Sydney Metro West – Westmead - Telstra and Jemena Utility Relocations

Heavy Vehicle use of Local Roads (HVLR) Application

Document Number 4271-SMW-HVLR-002
VERSION 02

DOCUMENT NO.	TITLE	VER	STATUS	NO.	DATE	COMPANY	RAISED BY	REVIEW DOC. NO.*	DOCUMENT REF*	DEED REF*	COMMENTS / RESPONSE	COMMENT CATEGORY*	CLOSED OUT
SMWSDDS-QWY-WMD-TF-PLN-000354	Westmead Heavy Vehicle Local Roads Use	A.01	RVW	01	21/09/2023	TFN	LWILBY	SMWSDDS-QWY-WMD-TF-PLN-000354	4.5 Cyclists	NA	The second sentence refers to cyclists 14 years and under, the road rule has been changed. Please update to align with this change - "children under 16 years old due to the proximity of"	Observation	N
					5/10/2023	QWAY	LCASEY	SMWSDDS-QWY-WMD-TF-PLN-000354	4.5 Cyclists	NA	Noted. Section 4.5 (second sentence) updated to reflect the change in road rules as advised.	Observation	N
				02	21/09/2023	TFN	LWILBY	SMWSDDS-QWY-WMD-TF-PLN-000354	4.5 Cyclists	NA	The second dot point currently refers to minimising or eliminating movements outside of school peak periods. Please reword so it captures the intention of minimising or eliminating movements during school peak periods. Thanks.	Observation	N

Figure 10 - Sensitive Receivers Locations

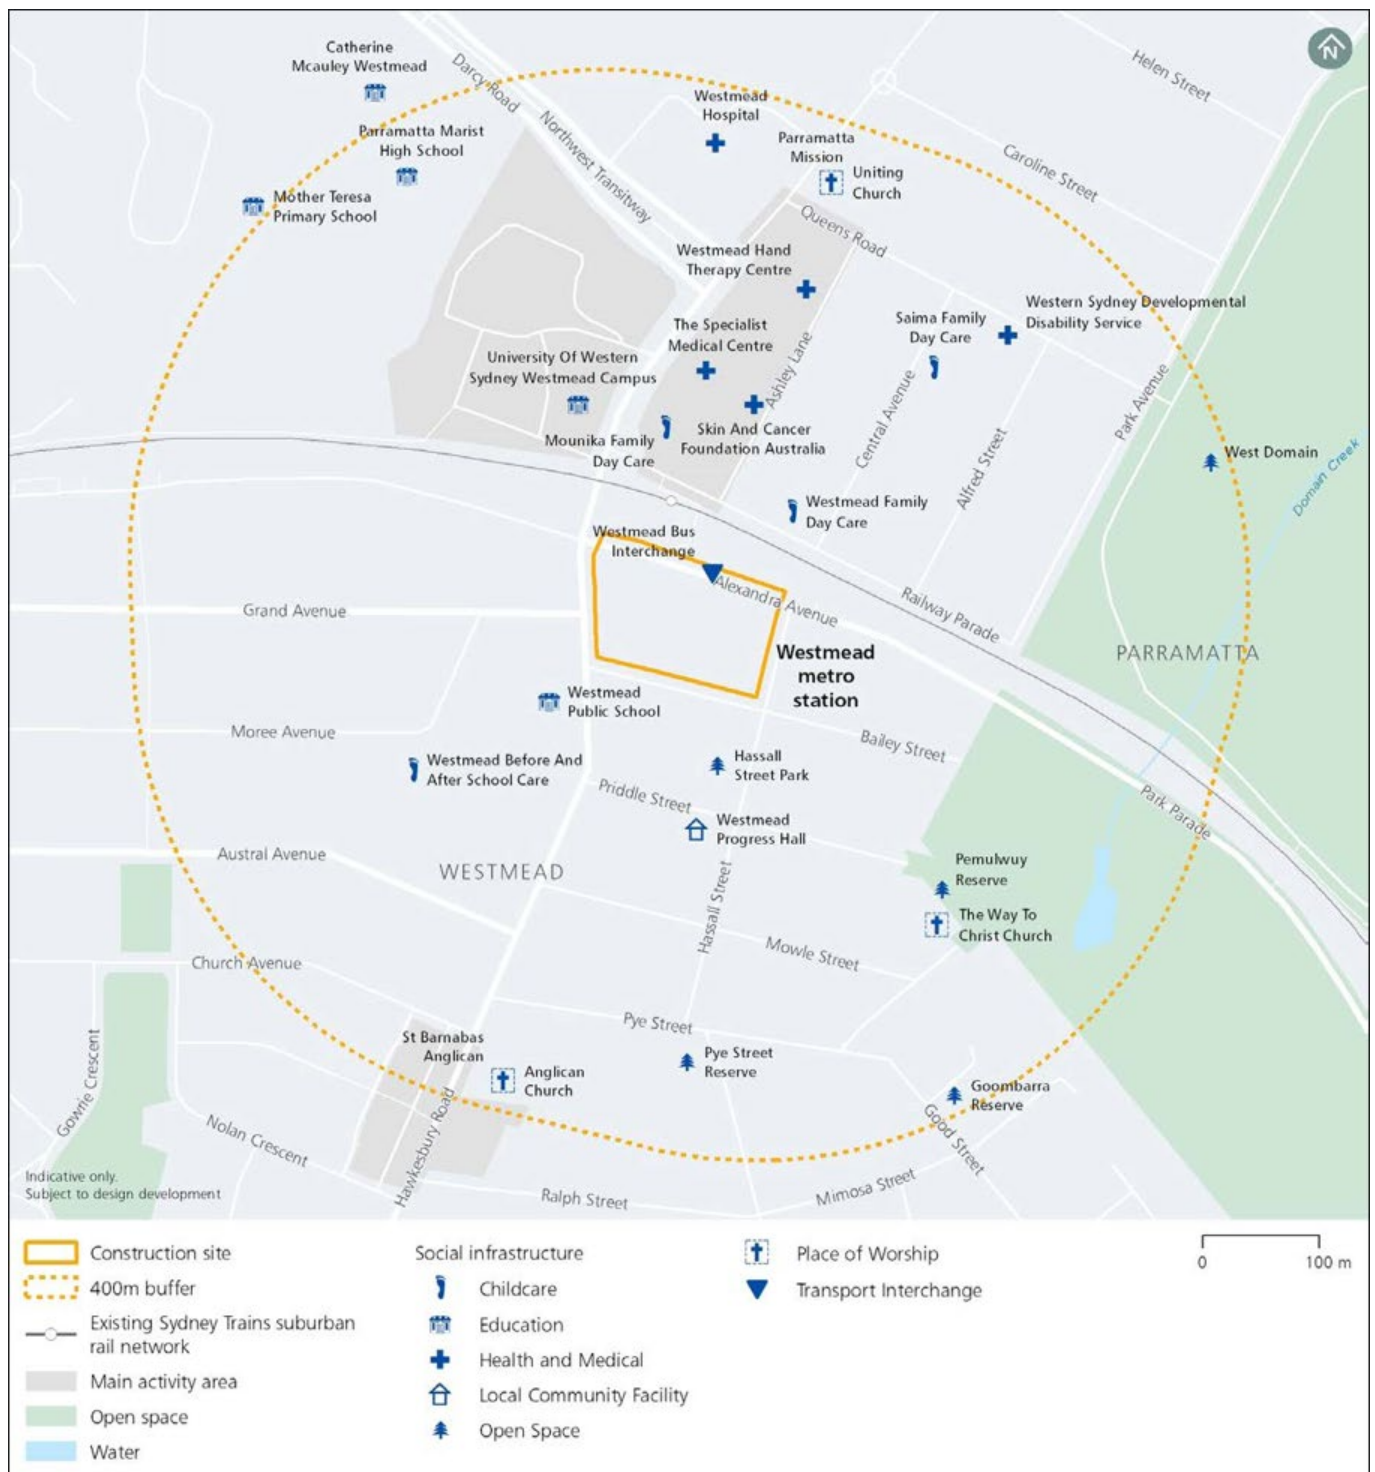
Figure 10	Image replaced	New image with improved clarity
	Section 7	As original.	Additional stakeholder listed; ER (Environmental Representative)
	Appendix E	Original transmittal of dilaps from Quickway to Sydney Metro deleted.	Transmittal of dilaps from Sydney Metro to Cumberland City Council now included.
	Section 4.8	used by the Project, have been completed and provided to Cumberland City Council.	used by the Project, were completed on 18th September 2023 and provided to Cumberland City Council on 19th September 2023 .
	Section 4.7.1	First sentence as original. Banks Public School is located on Hawkesbury Road.	Westmead Public School is located on Hawkesbury Road.
	Appendix C	SP-09 updated and up-revved SP-05 updated and up-revved	SP – 09-R1 SP – 05-R1
	Appendix B	SP-09 updated and up-revved SP-05 updated and up-revved	SP – 09-R1 – 5-point-turn. HV's are not permitted to enter the private driveway to perform this turn manoeuvre. SP – 05-R1

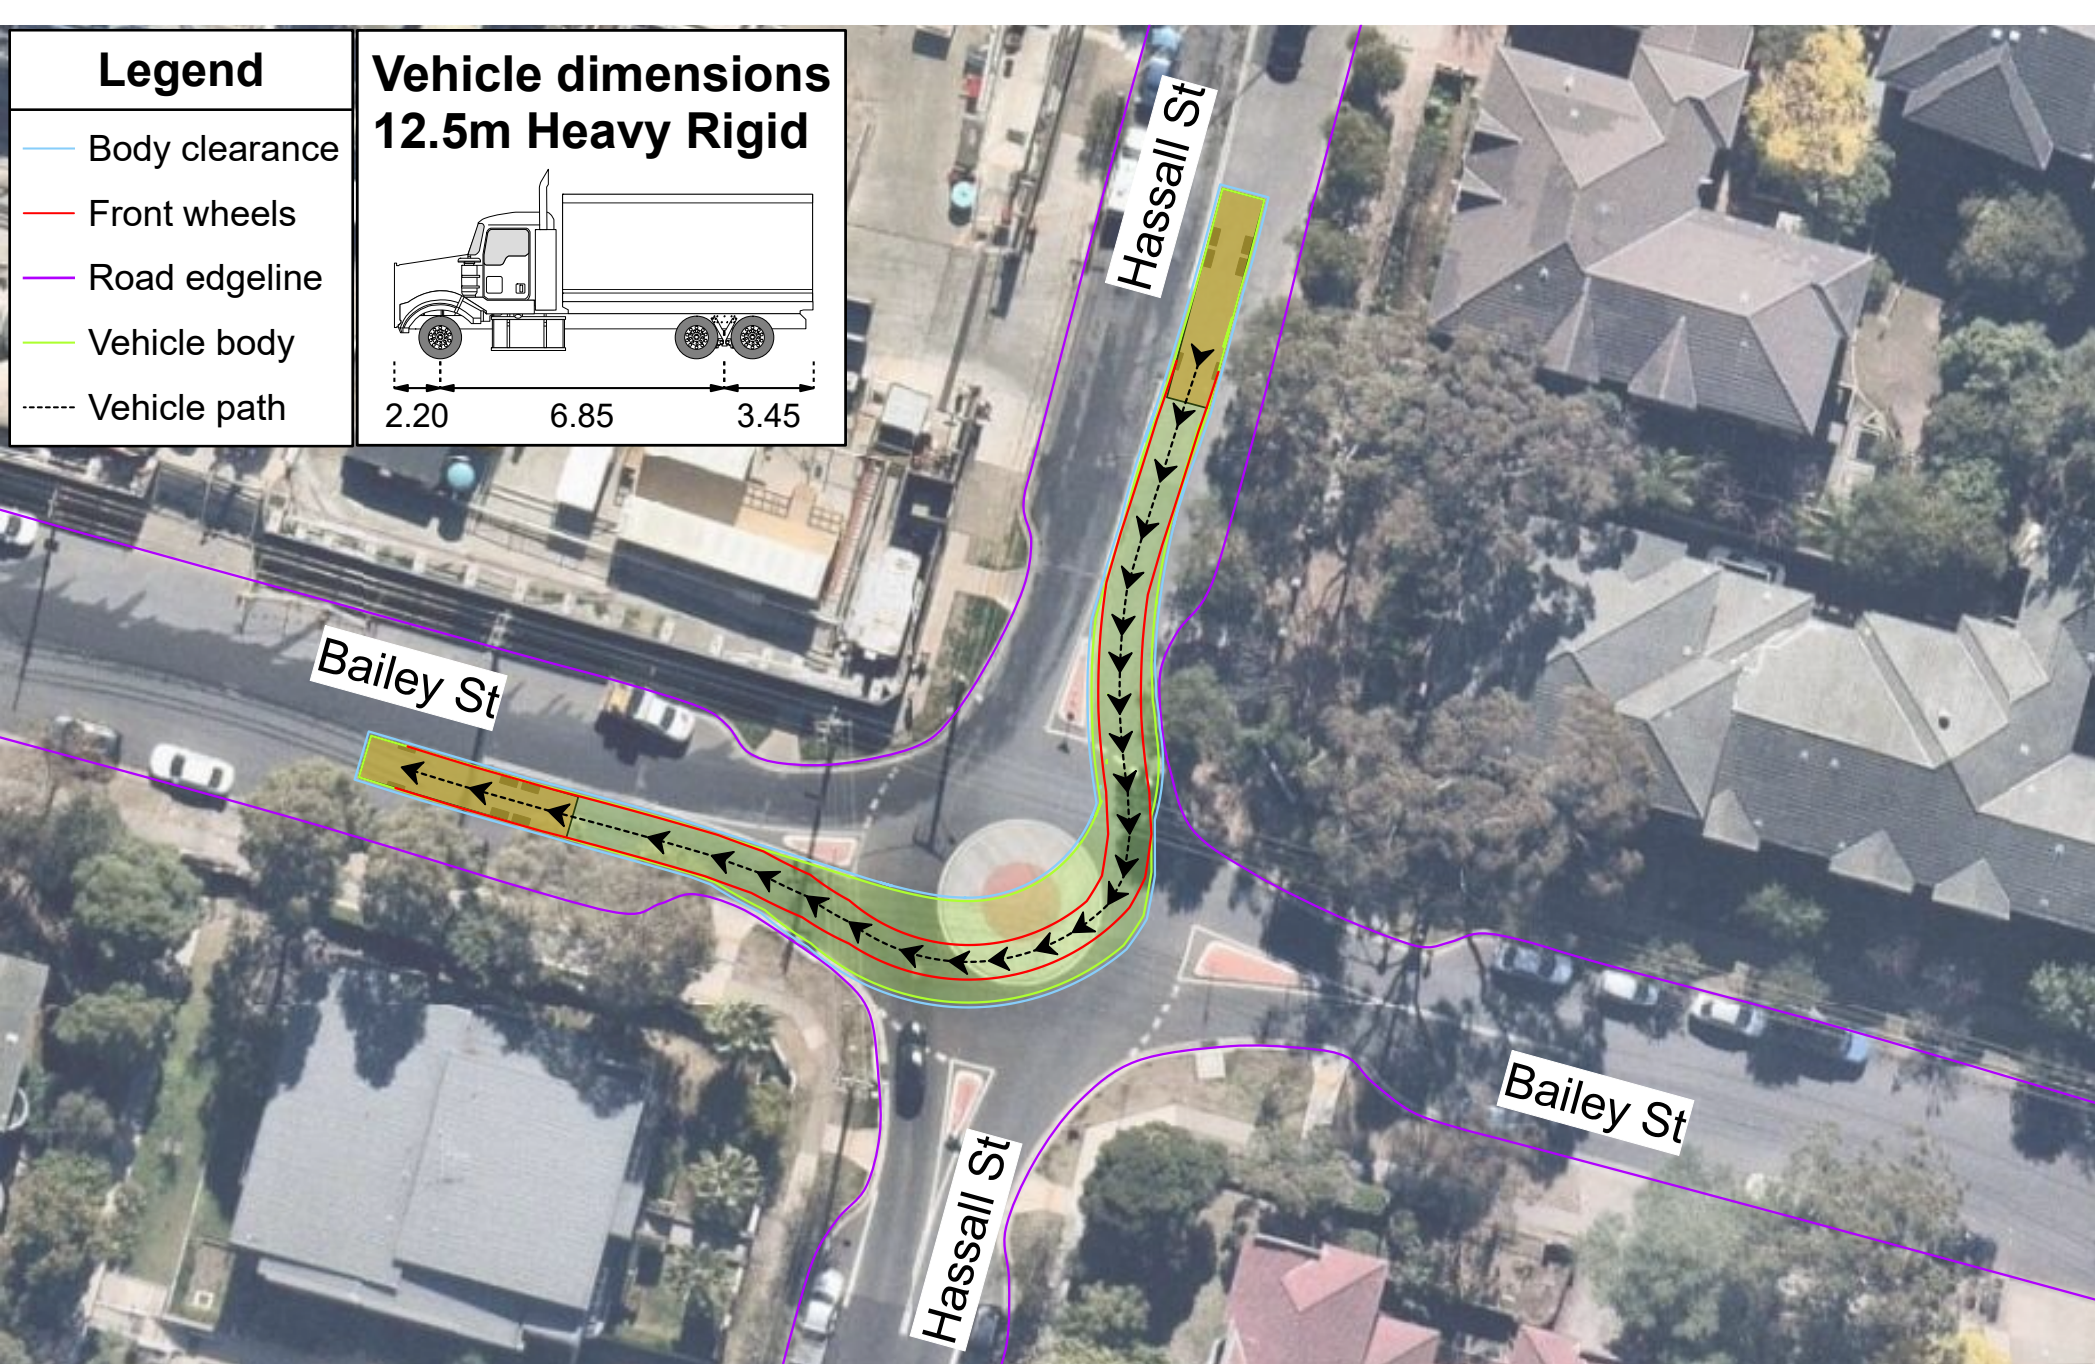
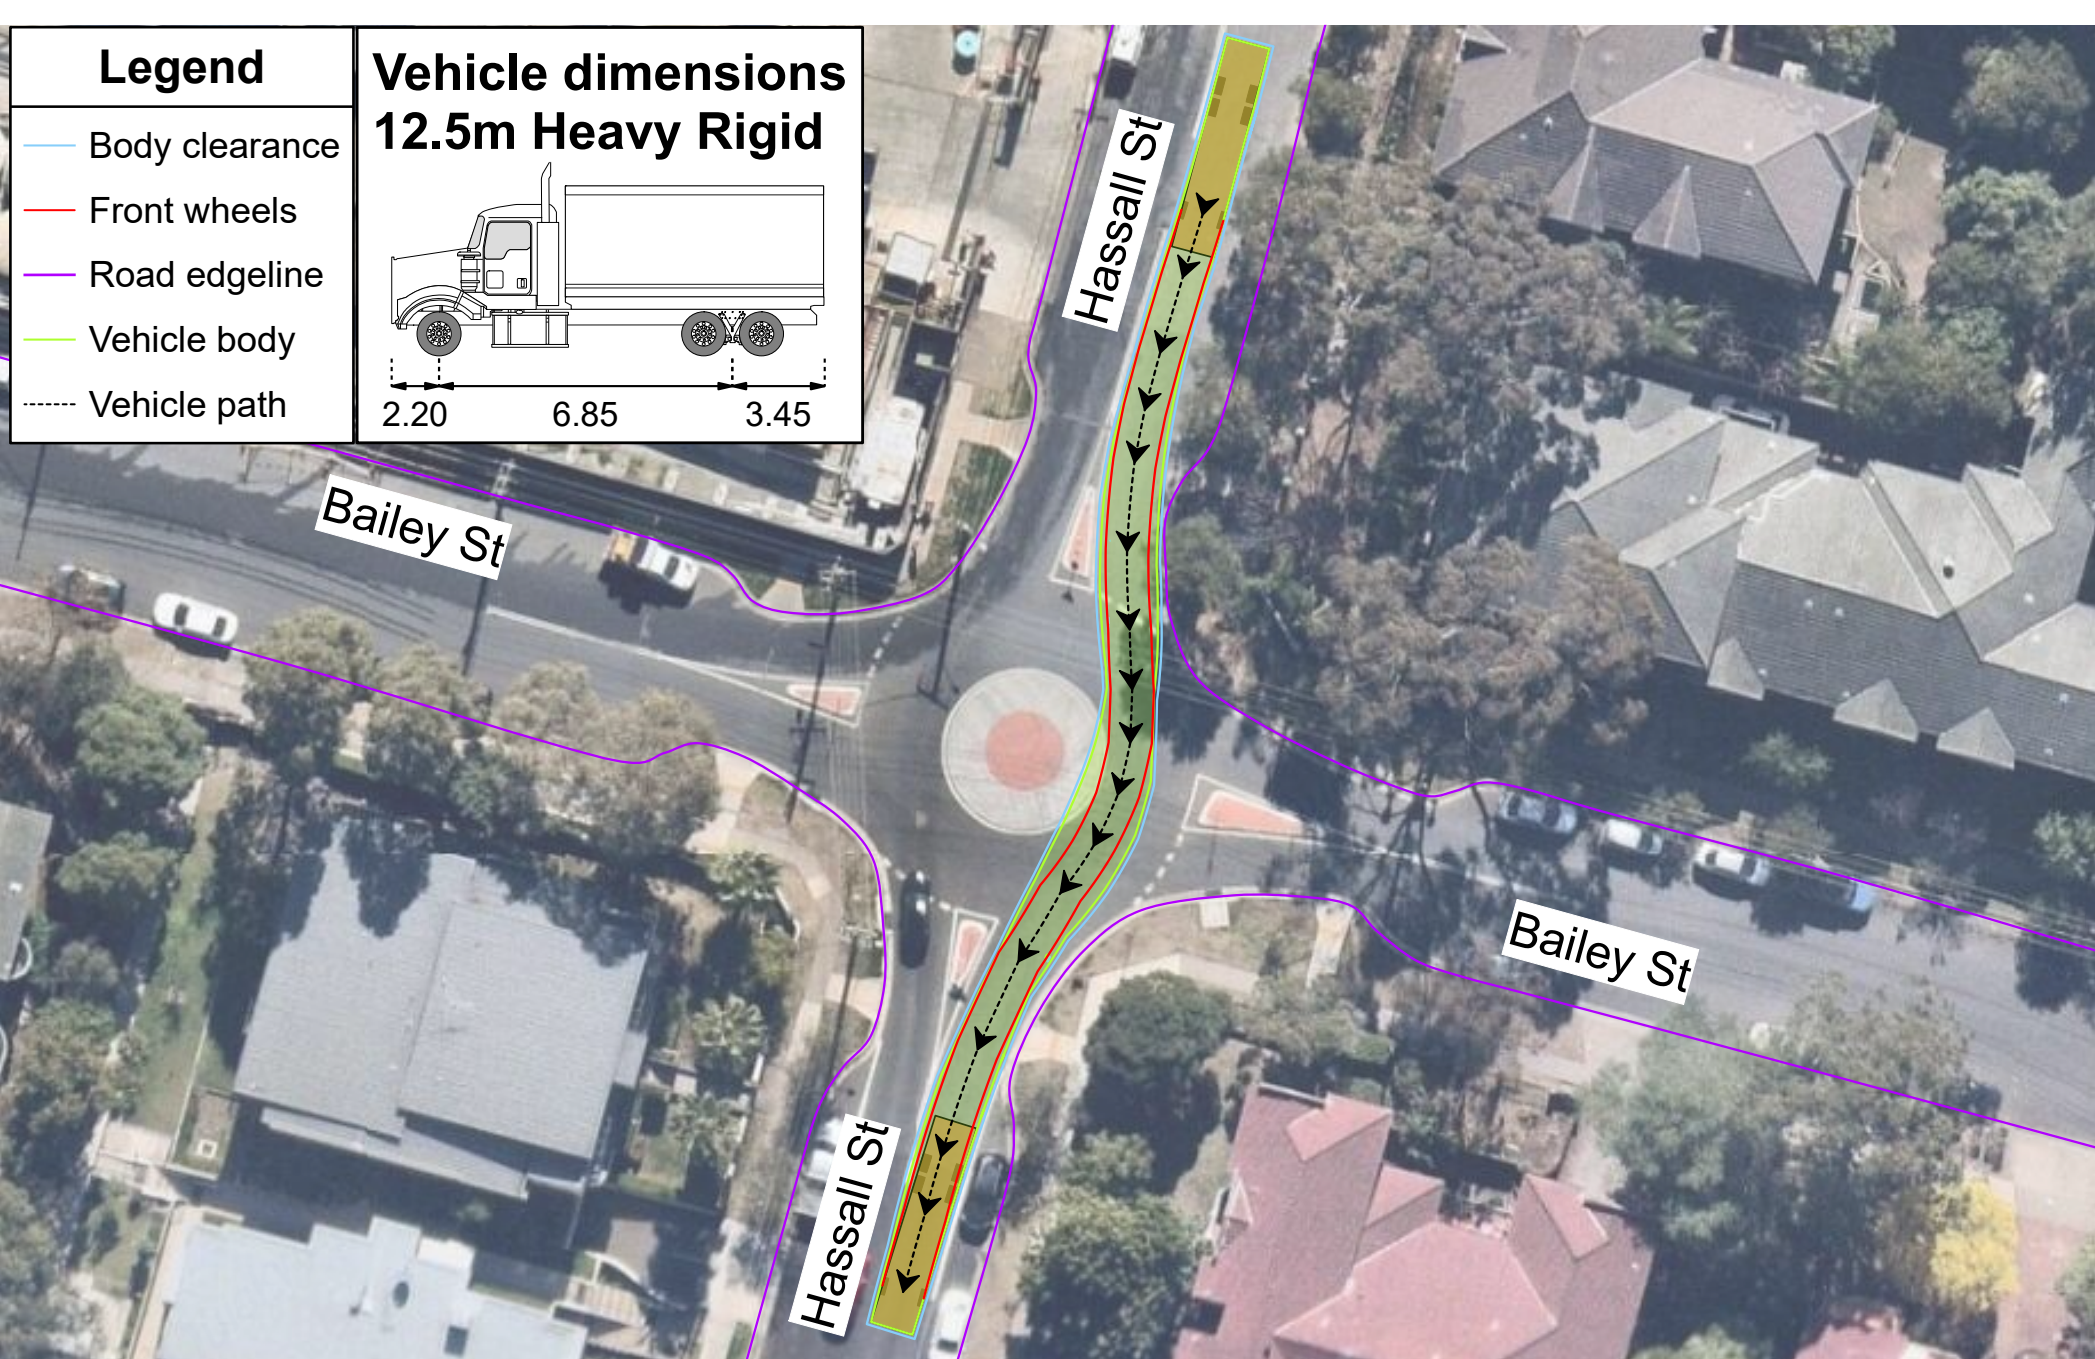
05	26/09/2023	SCO	DCROWLY	SMWSDDS-QWY-WMD-TF-PLN-000354	Appendix C – Plan SP-05 & Plan SP-06	-	Both swept paths have a 12.5m Heavy Rigid vehicle driving over the roundabout. Is the roundabout to be removed?	Observation	N
					7/10/2023	QWAY	LCASEY	SMWSDDS-QWY-WMD-TF-PLN-000354	Appendix C – Plan SP-05 & Plan SP-06	-	The roundabout removal is outside of Quickways scope. This is in GLC's scope of works. Quickway have planned the Project based off the existing road configurations/conditions at the time of development.	Observation	N
				06	26/09/2023	SCO	DCROWLY	SMWSDDS-QWY-WMD-TF-PLN-000354	Appendix C – Plan SP-09	-	A reversing 3-point turn, into a private driveway will not be accepted. Please update TMP.	Actual Non-Compliance	N
					7/10/2023	QWAY	LCASEY	SMWSDDS-QWY-WMD-TF-PLN-000354	Appendix C – Plan SP-09	-	Noted. Appendic C - SP-09 updated and up-revved to ensure there is no encroachment onto the private driveway.	Actual Non-Compliance	N
